Secure 1000 Radiation Emission
Measurement

FORM R-0646-1
(Single Pose)

Re: Rapiscan AIT System Radiation Survey Reporting

R-0646-1 Addendum (Documentation Errors)

Side View

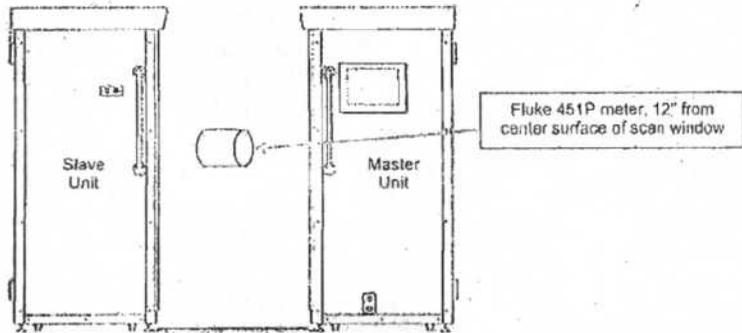
1. No value indicated for background radiation. Typical values range from 7uRem/hr to 13uRem/hr at sea level. Note: Absence of value has no adverse impact on calculations.
2. TABLE 1: Incorrect presentation of data in Column 3 for Measured Exposure. Indicated values are 34uR and 31uR. Corrected values are 3.4uR and 3.1uR.
3. TABLE 1: Incorrect presentation of data in Column 6 for Effective Dose. Indicated values are 19 uRem and 17 uRem. Corrected values are 1.9 uRem and 1.7 uRem.
4. Technician did not initial pass or fail check box.
5. Technician did not print his name.

The service technician should attend refresher training.

The corrected data indicates this system was operating within expected parameters. No re-survey is required for this system.
